NOTICE TO OFFERORS
NOTICE OF INVITATION OF BID
PRC RW 3R-21L RSA Improvements Project
PRC Project No. 2010DB003
FAA AIP NO. 3-04-0030-032 & -033
ADOT Project No. E1F52 and E2F97
ADDENDUM #2
November 18, 2011

Runway 3R-21 Safety Area Improvements

Pre-Bid Conference Meeting Minutes

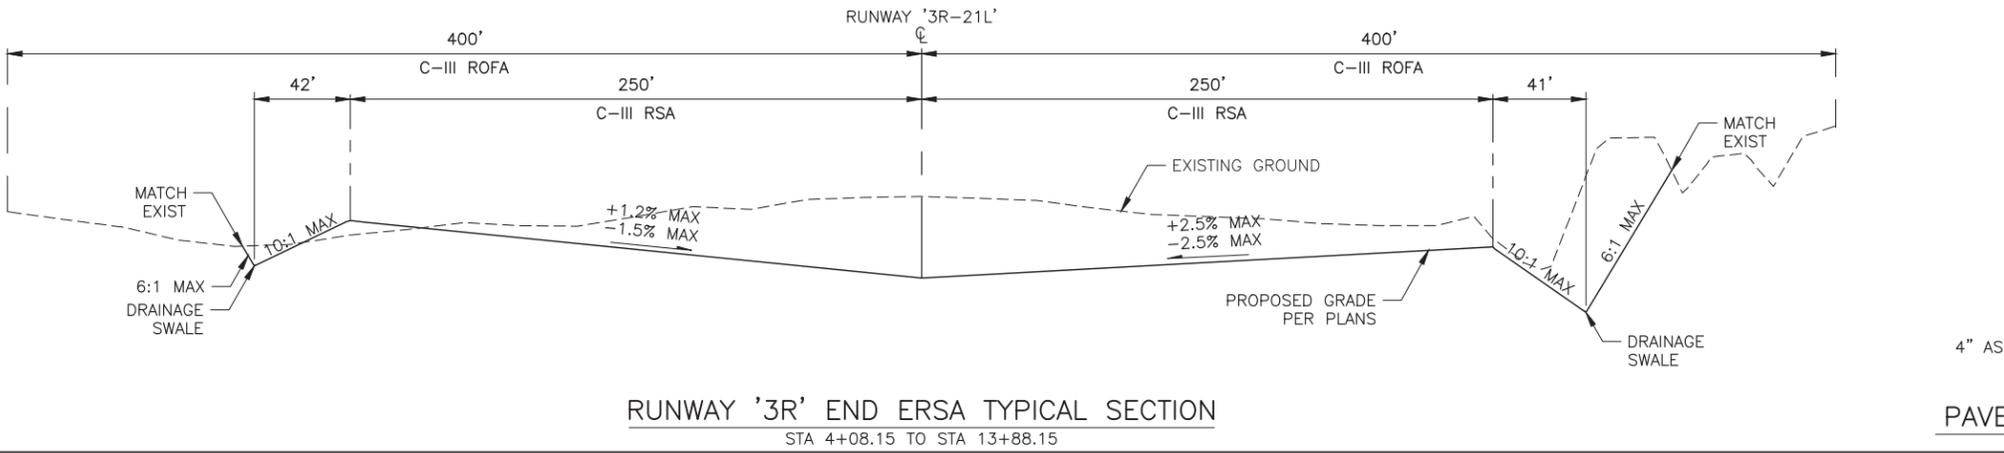
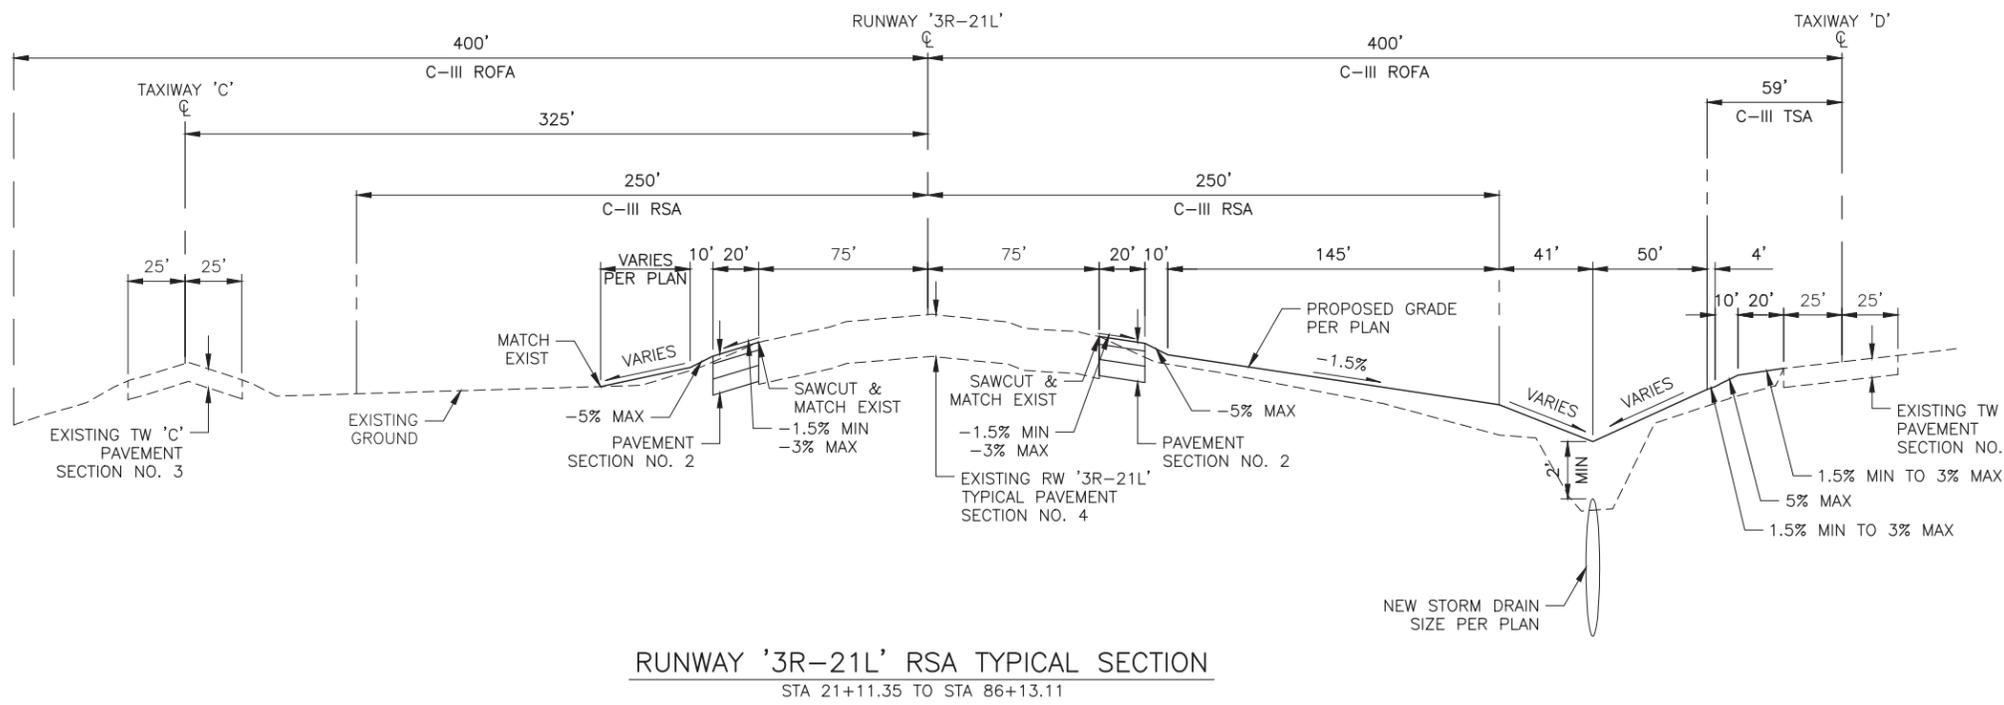
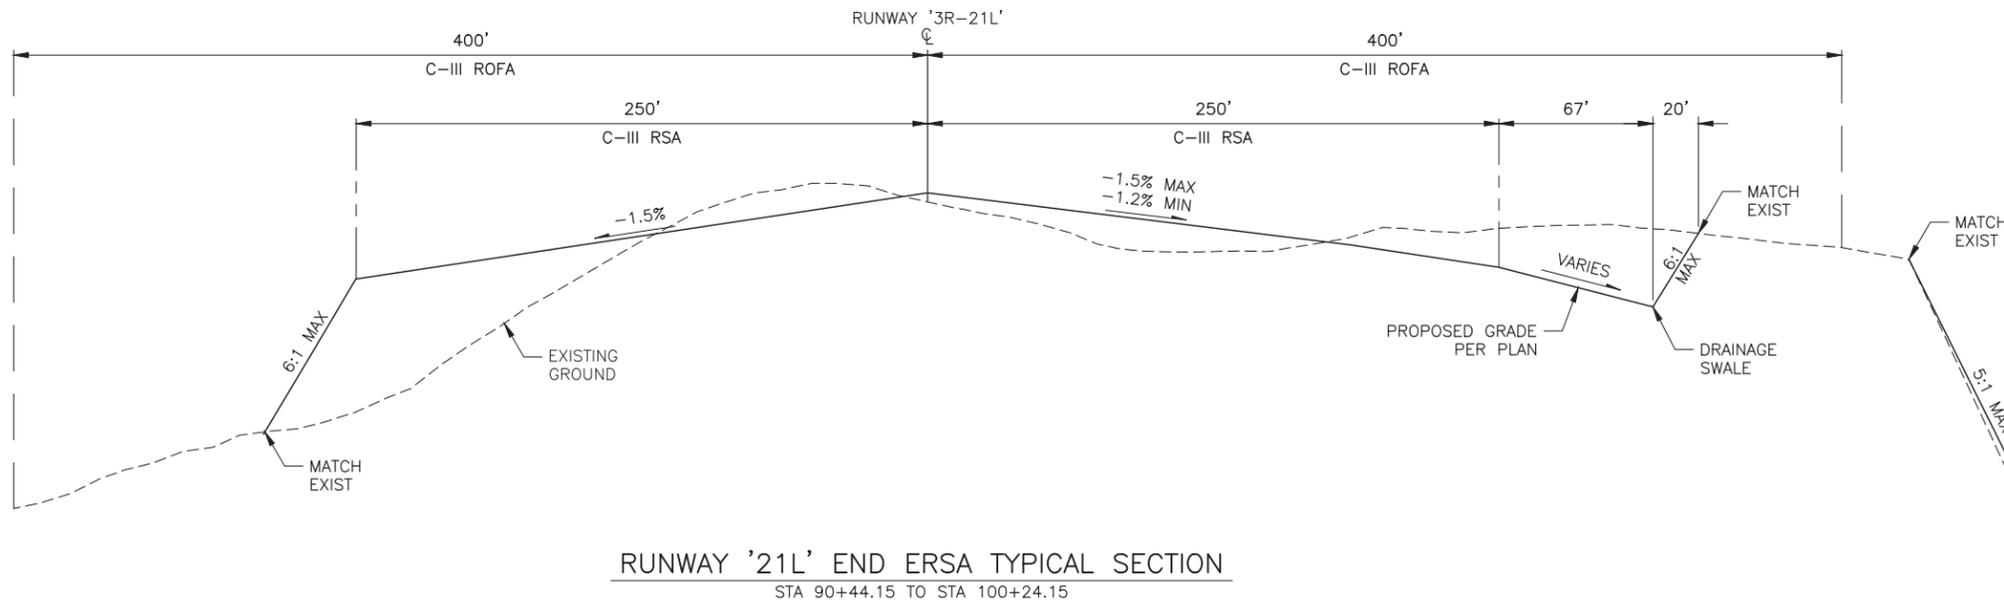
1. Page P-201-6 of Division V – CIVIL TECHNICAL SPECIFICATIONS of the Contract Documents; **INSERT** the attached Specification *ITEM P-209 CRUSHED AGGREGATE BASE COURSE (FAA)*, pages P-209-1 through P-209-6, after Specification *ITEM P-201 CRUSHED AGGREGATE BASE COURSE (MAG)*.
2. Page L-100a-5 of Division V – ELECTRICAL TECHNICAL SPECIFICATIONS of the Contract Documents; **INSERT** the attached Specification *ITEM L-105 Temporary Lighting*, pages L-105-1 through L-105-4, after Specification *ITEM L-100a Fixture and Sign Testing*.
3. Pages L-880-1 to L-880-6, of Division V – ELECTRICAL TECHNICAL SPECIFICATIONS of the Contract Documents; **REMOVE** in its entirety and **REPLACE** with attached pages L-880-1 to L-880-6, *Item L-880 Installation of Precision Approach Path Indicator (PAPI) System, (REVISED 11.18.11)*.

P-209 Crushed Aggregate Base Course shall only be required for construction at the Runway 3R-21L and 12-30 intersection as shown in the typical section provided in the plans.

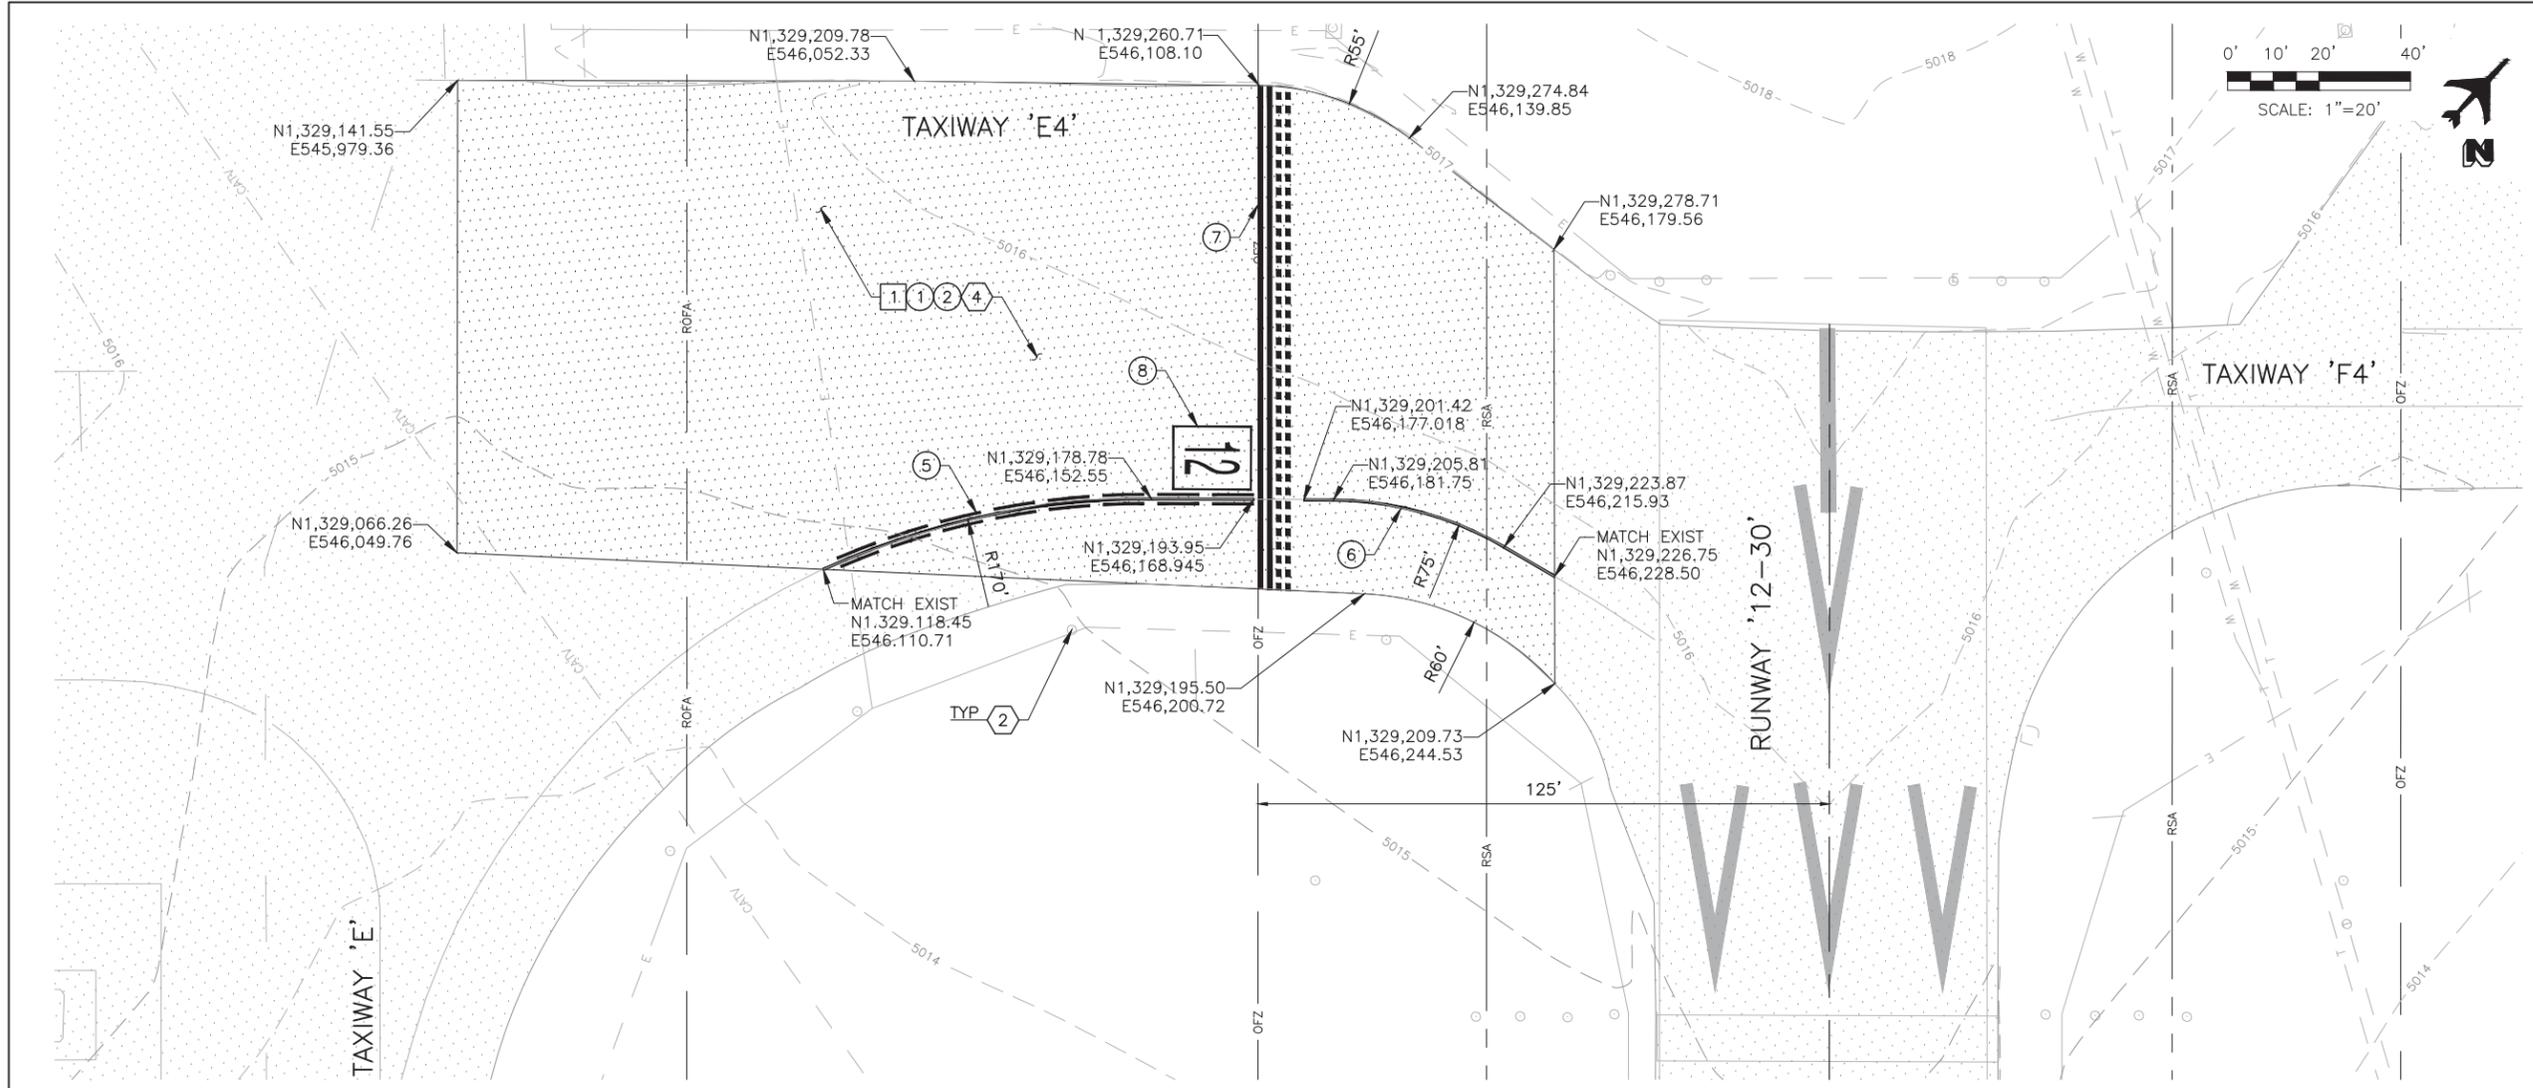
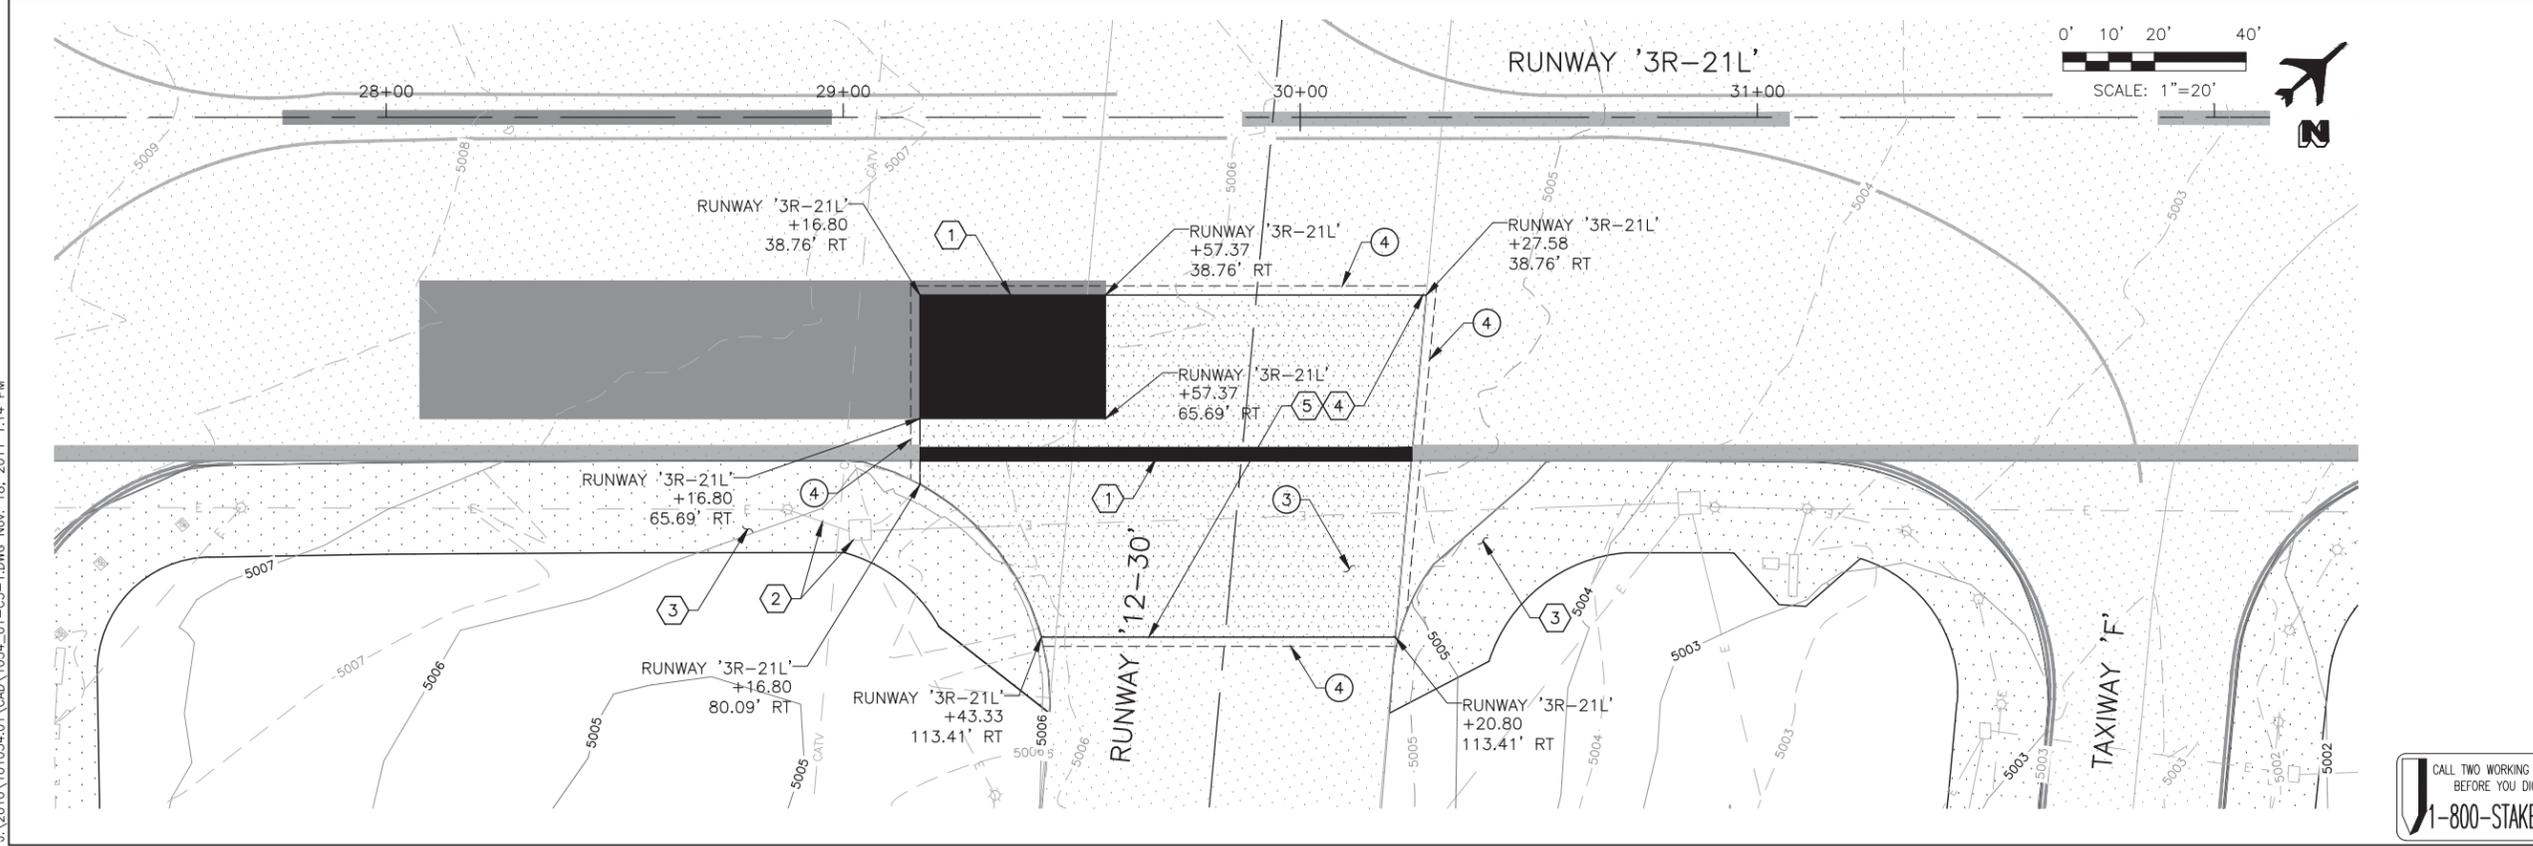
1. **REMOVE** the following Construction Plan Sheets: G1.3, G1.4, G2.1, G2.7, G3.1, G3.2, C3.1; and **REPLACE** with the following Construction Plan Sheets (attached, Delta No. 1 revision date 11.18.11): G1.3, G1.4, G2.1, G2.7, G3.1, G3.2. Major changes include:
 - a. Revised Quantities.
 - b. Alternate Haul Route for Bottleneck Local Borrow Stock Pile identified.
 - c. Additional Temporary Lighting general note added for all phases.
 - d. Revised Typical Pavement Sections for Runways and Taxiways.
 - e. Revised Typical Pavement Section for the 24-hour pavement rehabilitation at the Runway Intersection.
